PART 21 - POTENTIAL DEFECT IN NUS-710DU TRIP UNIT TO PRODUCE A VALID TRIP OUTPUT SIGNAL

Letter Number: AVC-14-005

Subject: 10 CFR Part 21 Report Notification, NUS710DU Trip Units

NUS-710DU0TT; A Master Trip Unit manufactured by Scientech.
NUS-710DU0TS; A Slave Trip Unit manufactured by Scientech.

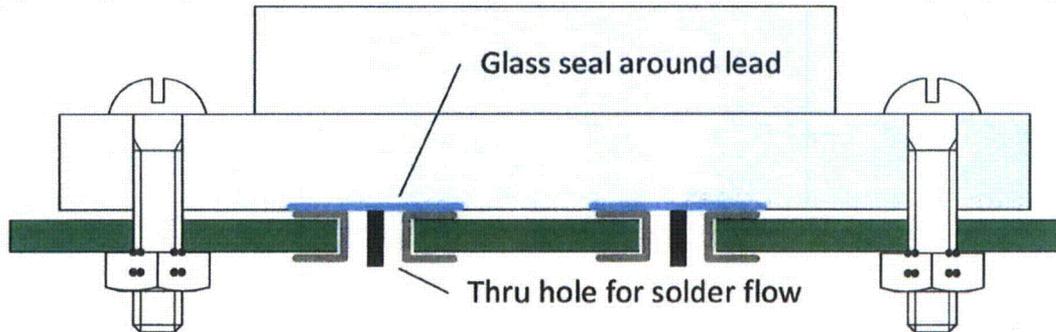
In certain operating configurations, NUS-710DU Trip Units could fail to produce a valid trip output signal.

Transistor Q8 on the referenced units uses a TO-66 package and is flush mounted on the component side of the PCB. The TO-66 package, based on JEDEC drawing TO-213 does not specify the size of the glass-sealed holes in the case (collector) around the base and emitter leads. Random samples measure approximately 0.11" in diameter. The PCB includes standard 0.100" solder pads on both non-component and component sides. During manufacture, Q8 is secured using screws and nuts with leads centered in the through-holes, so no direct solder pad to case contact is possible. However, the presence of the pad on the component side could facilitate, under certain conditions, excessive solder flow, creating a close proximity, or in the extreme case bridging, between solder on the emitter or base solder pad and the Q8 case. Permanent bridging would be detected during acceptance testing. However, in at least one case, with the trip unit mounted in the trip unit chassis via an extender card, the proximity was close enough to create contact when the board was slightly flexed.

In configurations (3) and (4), bridging at Q8 would prevent a valid trip signal from being generated by keeping the output at logic high.

1. Scientech has identified a design change that corrects the problem. The correction is to install spacers under Q8 to provide clearance from the board. The Design Change Notice was complete May 7, 2014.
2. Scientech has placed a hold on all affected in-house modules, and will incorporate the design change prior to ship.
3. Scientech will notify the plants listed per 21.21(d)(4)(vi) above, and offer to correct the affected units at Scientech's facility by close of business May 8, 2014.
